ADDENDUM NUMBER 01

RENOVATION OF SHERIDAN PARK PAVILION
4800 South Lake Drive
Cudahy, Wisconsin 53110

Date of Addendum: 6/16/2014

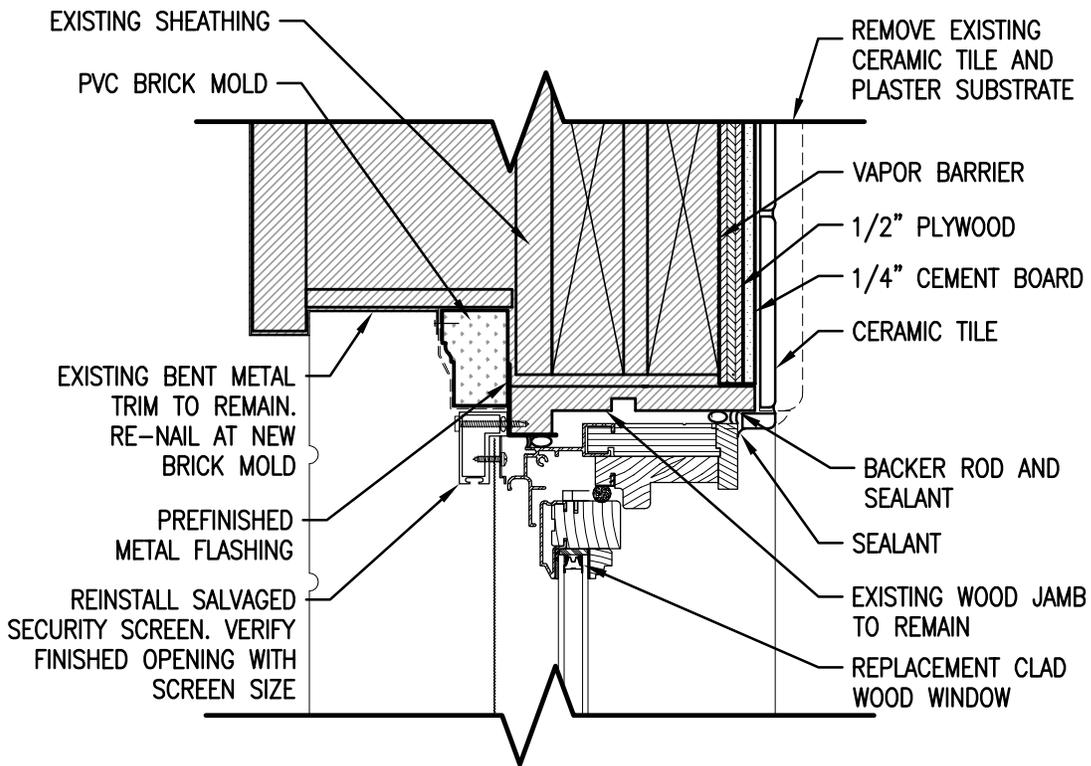
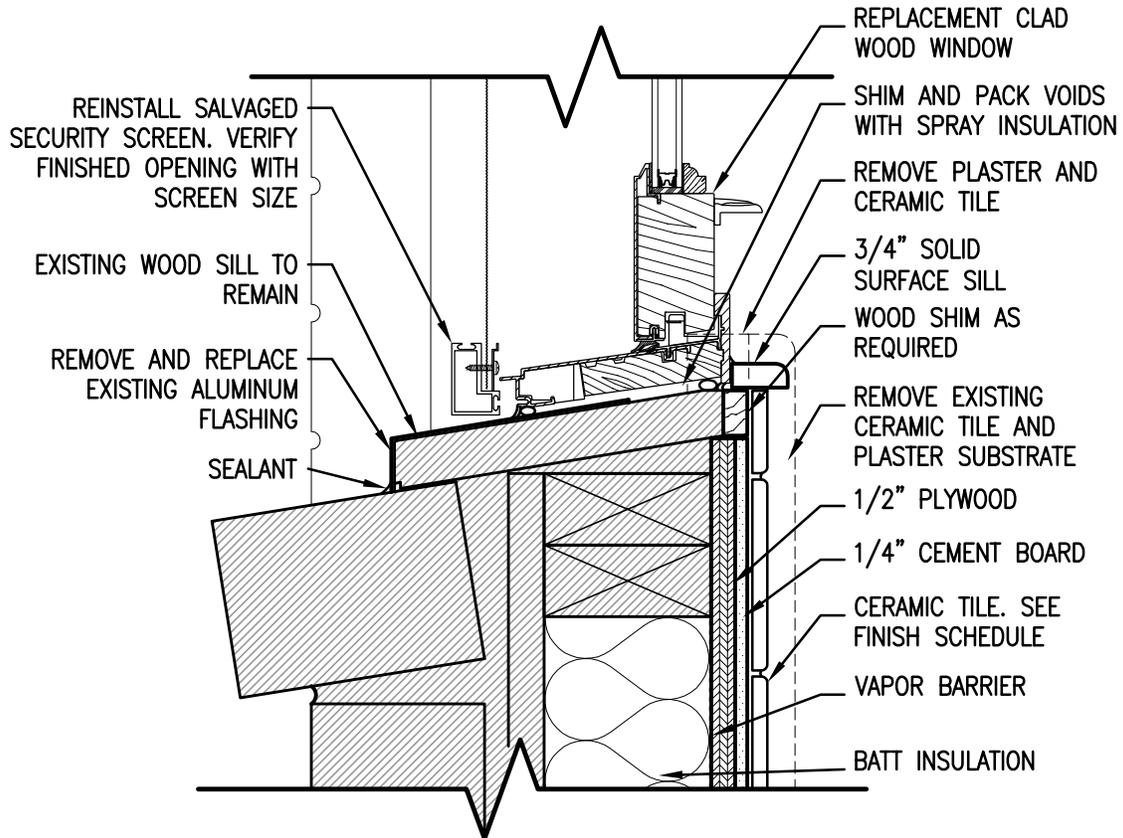
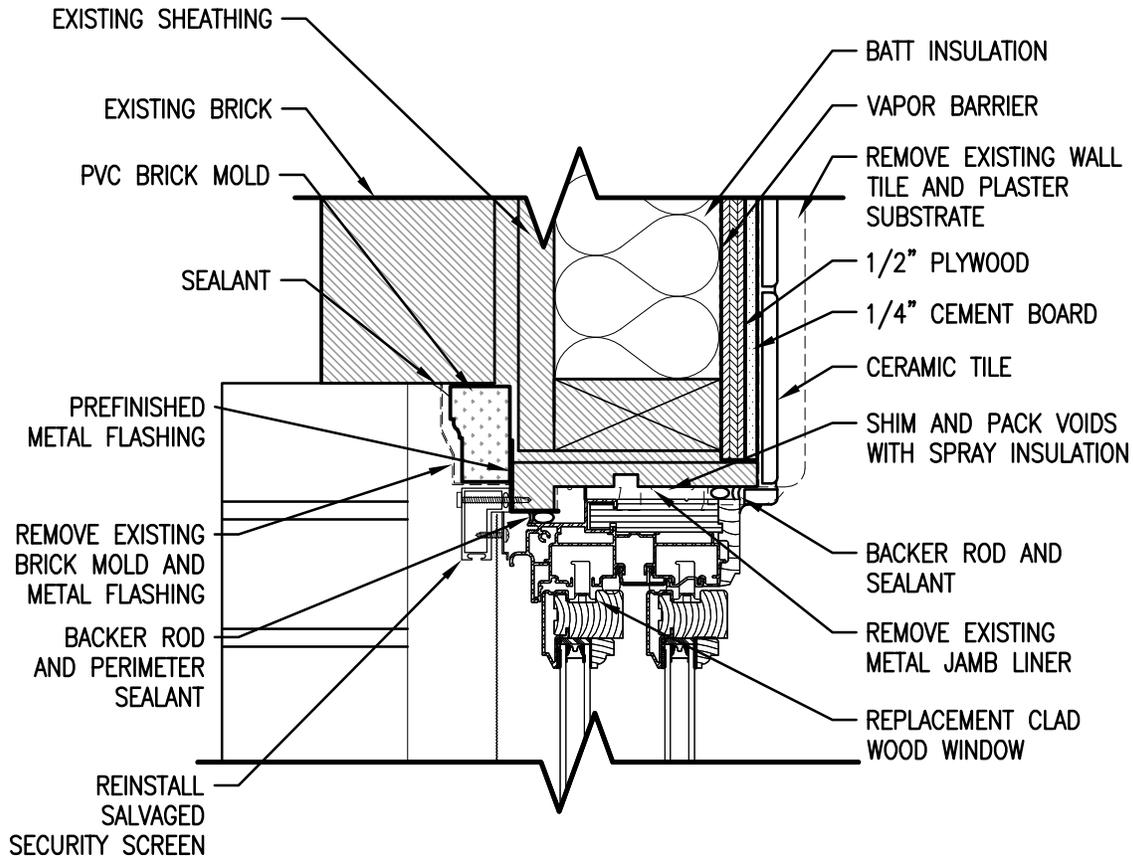
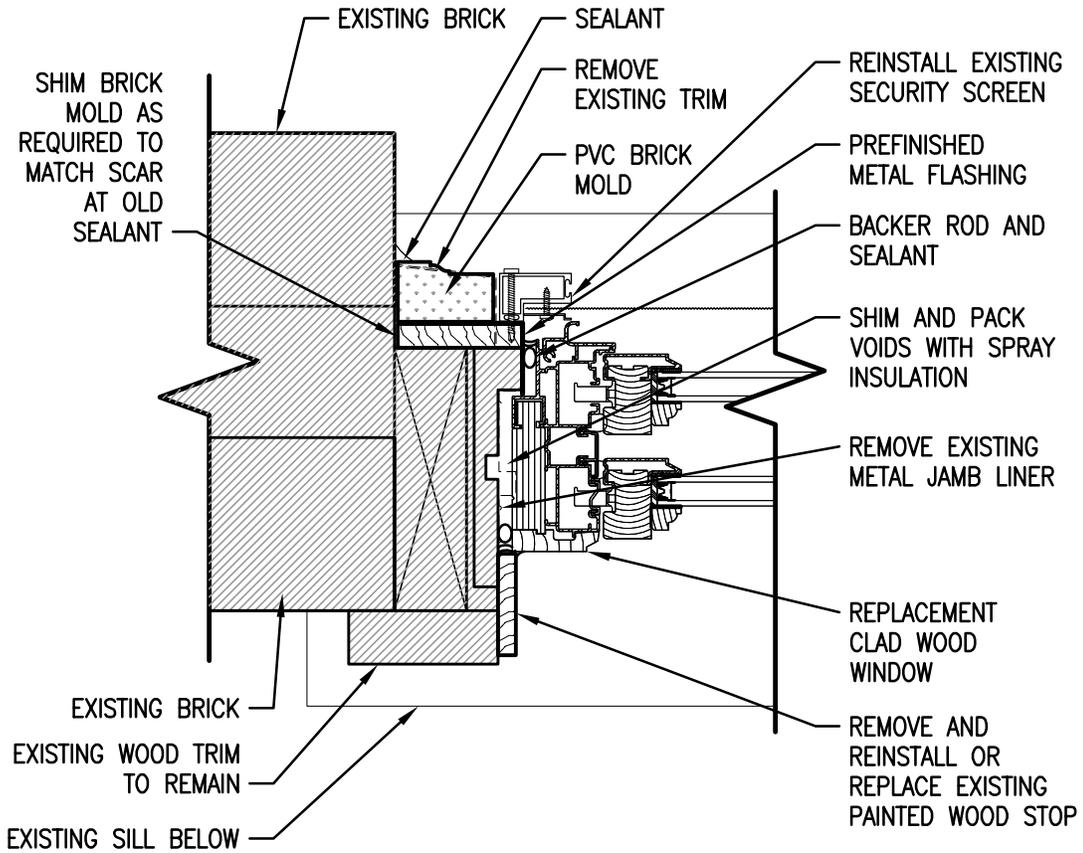
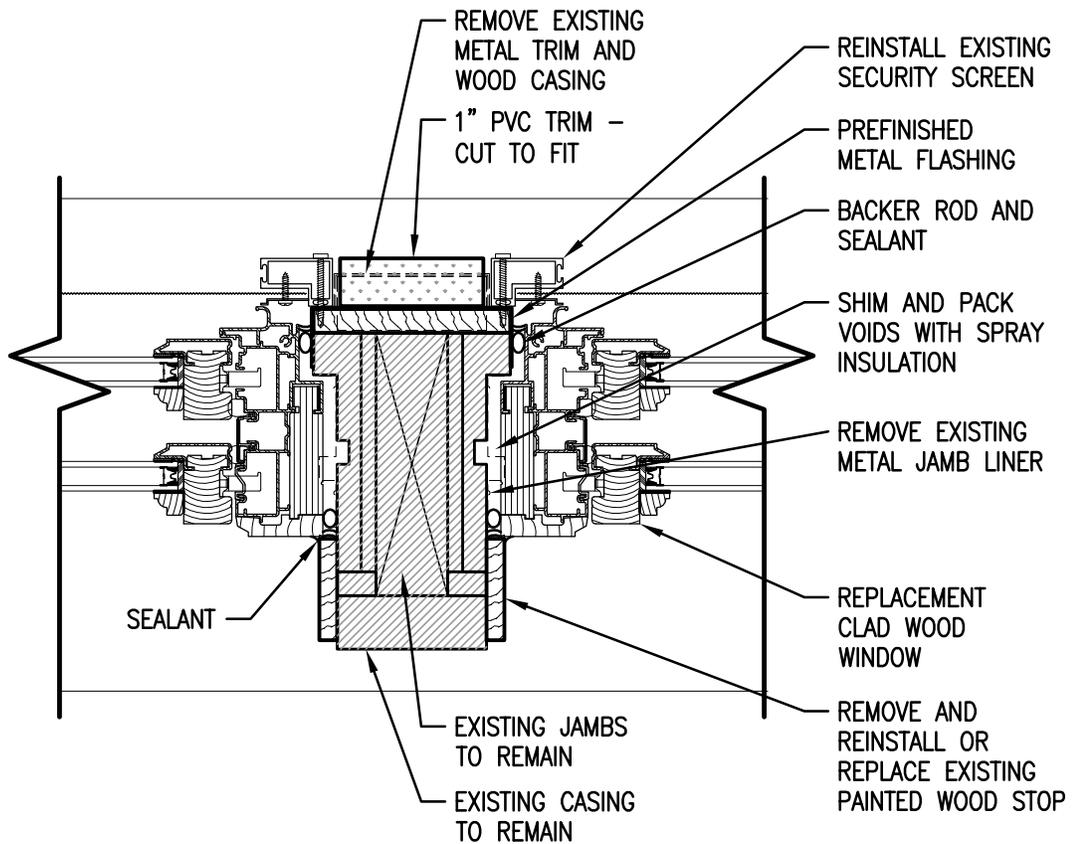
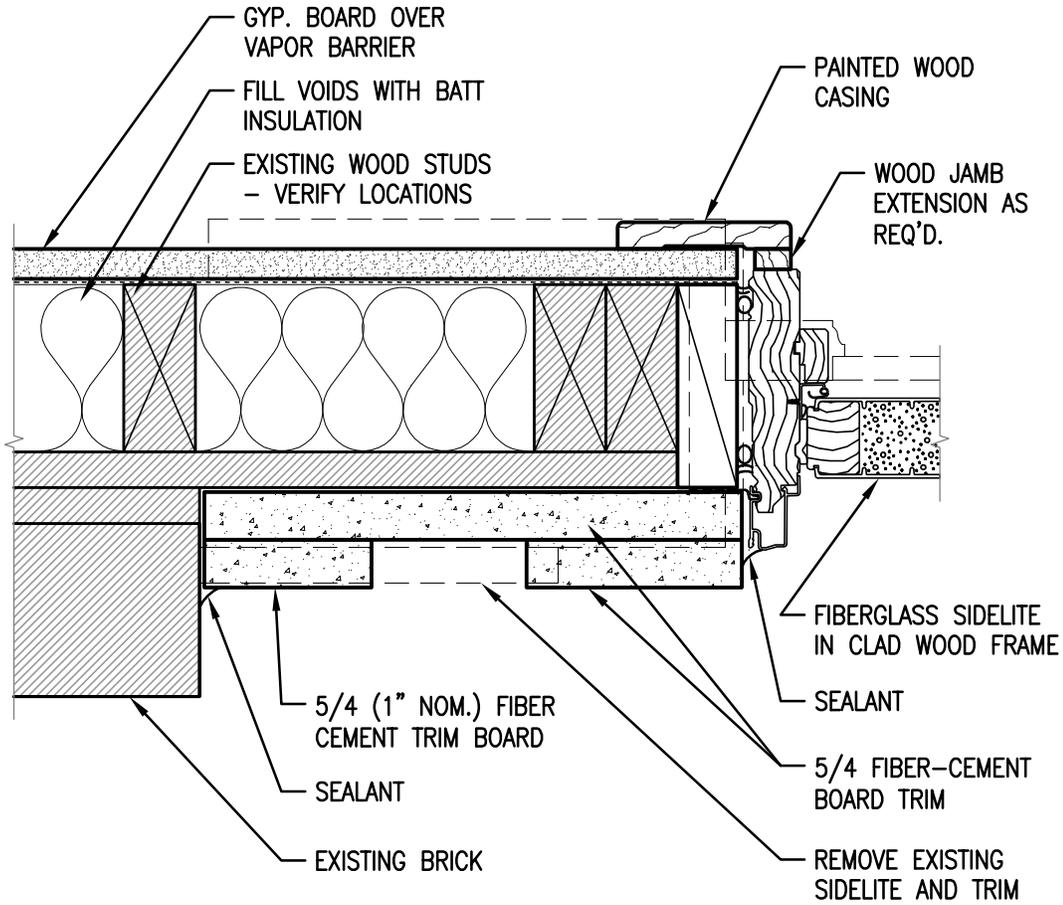
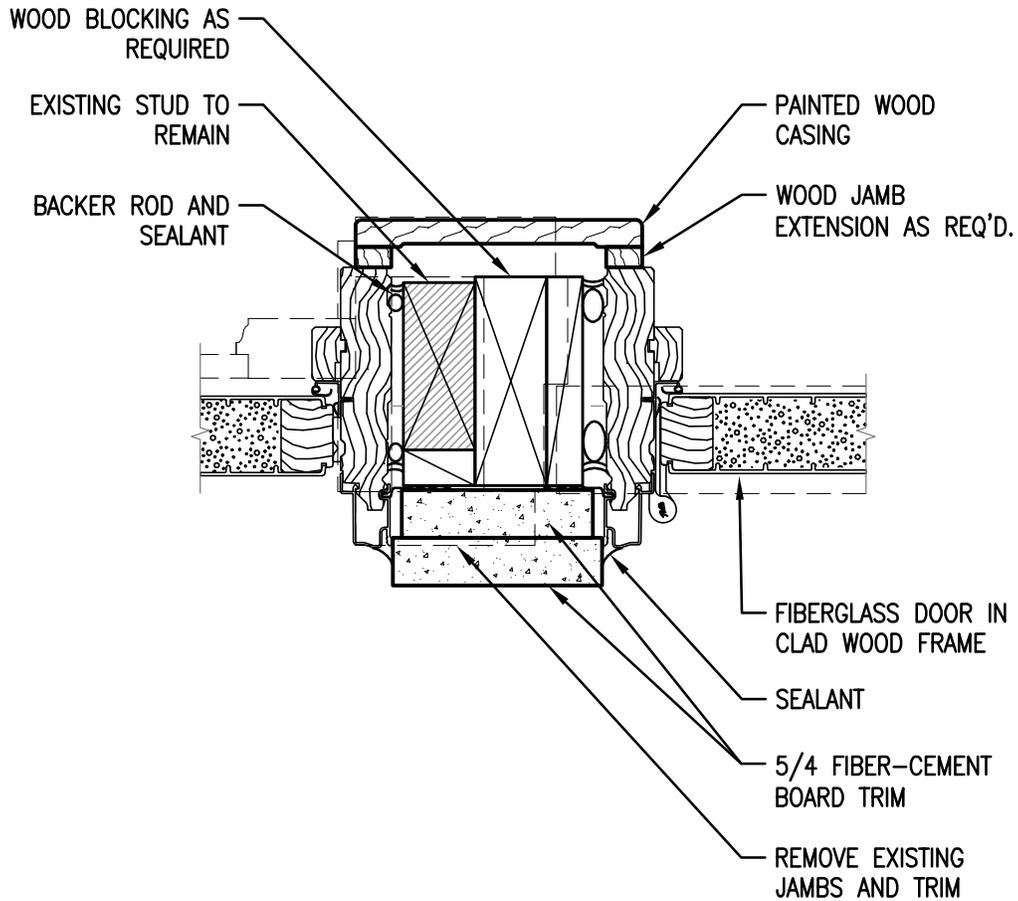
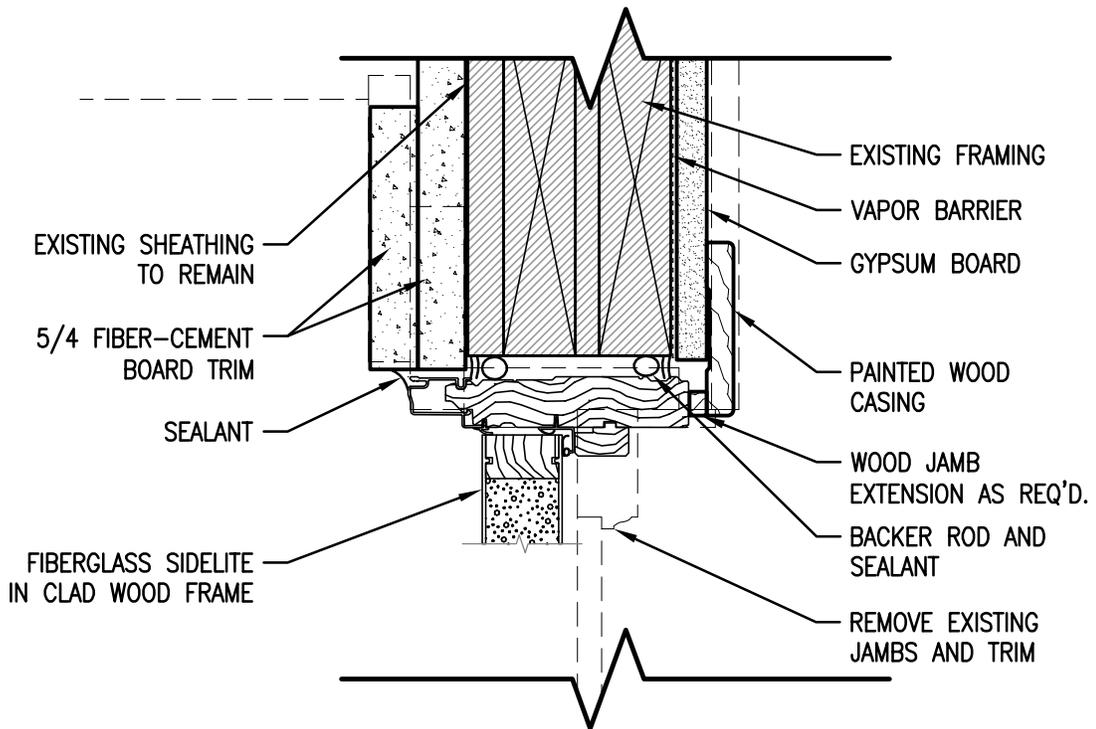
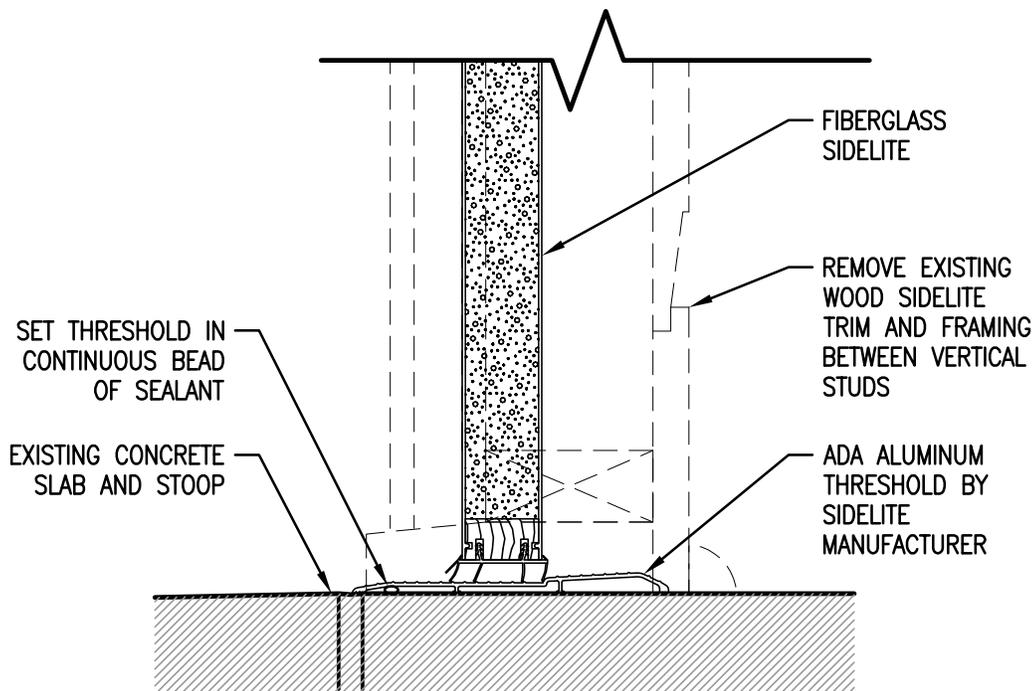
1. **Add** window details. See attached drawings A4.1-1, A4.1-2, A4.1-3, A4.1-4, A4.1-5, A4.2-1, A4.2-2, A4.2-3, A4.2-4, A4.2-5, A4.2-6, A4.2-7, A4.2-8, A4.2-9, A4.2-10
2. **Add** entry door details. See attached drawings A4.1-6, A4.1-7, A4.1-8, A4.1-9
3. **Revise** Detail 4A/A4.1 and 16/A4.1 to show the continuous drip edge to lap fascia board by least 1".
4. **Revise** all references to Prefinished Cement Board siding to be Pre-Primed Cement Board Siding.
5. **Revise** details 2/A4.1 and 3/A4.1 to alter the soffit and new door conditions. See attached drawings A4.1-9 and A4.1-10.
